**A Second White Paper Addressing Enhanced Radon
Releases from the K-65 Silos at the Fernald Site**

Contract No. 200-2009-28555

Prepared by U. Hans Behling, PhD
S. Cohen & Associates
1608 Spring Hill Road, Suite 400
Vienna, VA 22182

April 2010

Exhibit 1: Figure 15 from RAC 1998

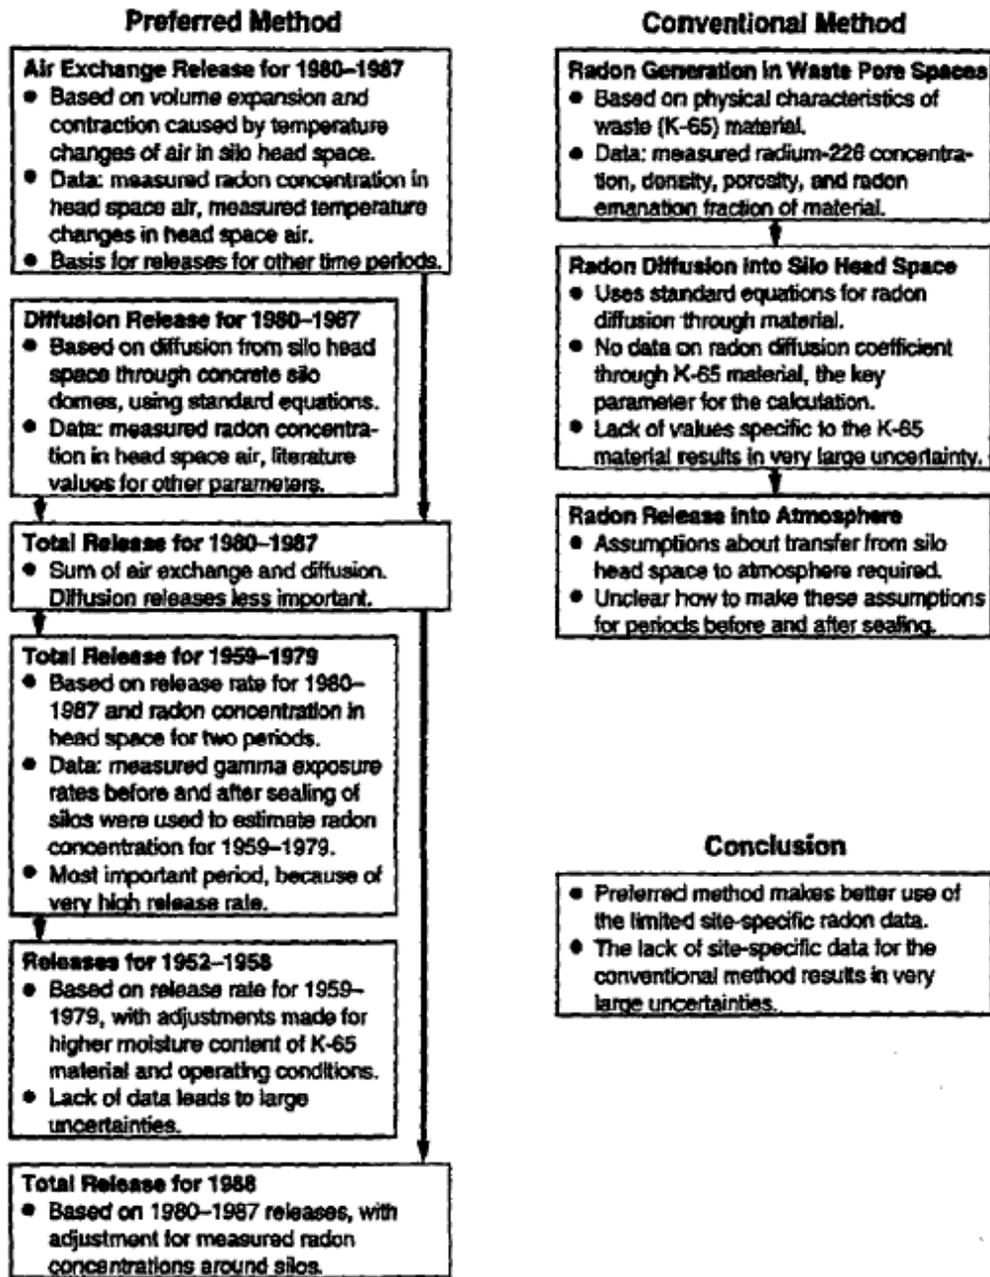
For convenience, “Figure 15” cited above is reproduced herein as Exhibit 1. Of significance are statements that acknowledge the limitations and high uncertainties of these models.

Exhibit 2: Figure 16 from RAC 1998

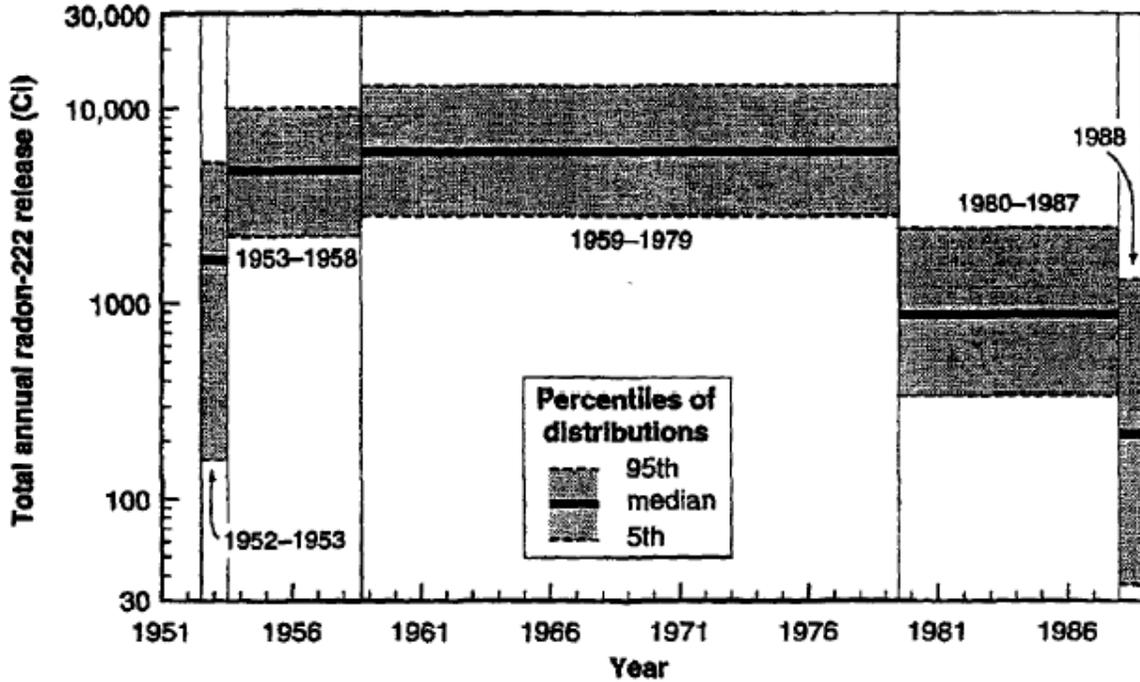
Revised estimates of annual release rates for the **preferred method** are cited by RAC (1998) in Figure 16 and reproduced herein as Exhibit 2. Figure 17 (reproduced herein as Exhibit 3) presents a comparison between release estimates derived in behalf of the RAC (1998) **preferred method** and the RAC (1995) **conventional method**. According to the authors of the two RAC reports, while the addition and/or refinements of model parameters only modestly affected the median values, there was a significant reduction in the uncertainty of release rates.

Exhibit 3: Figure 17 from RAC 1998

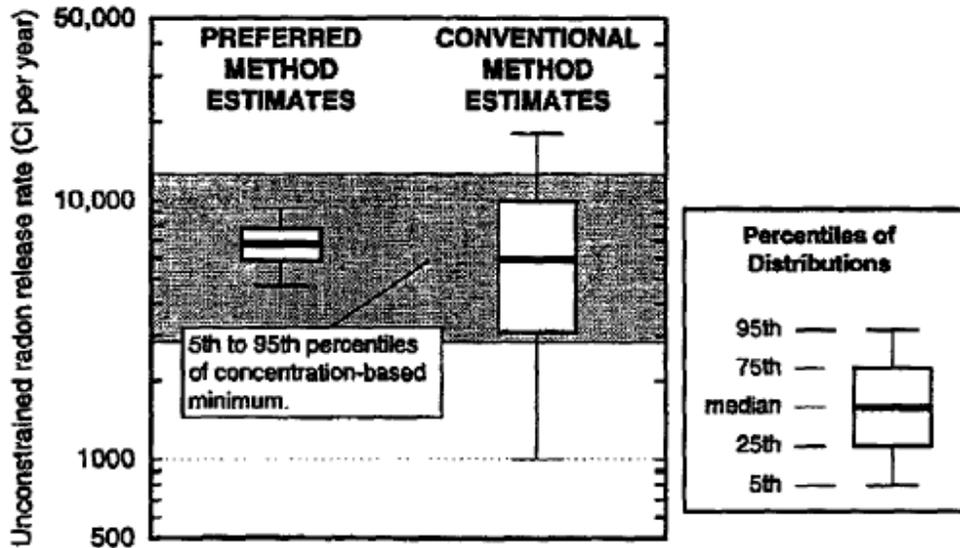
Inspection of Exhibit 3 also shows that, in addition to RAC’s **preferred method** estimates and its **conventional method** estimates, the authors identified yet a third method, referred to as the **concentration-based minimum unconstrained release rate**, shown by the gray band. The issue of “unconstrained” will be discussed in greater detail in Section 3.1 below.
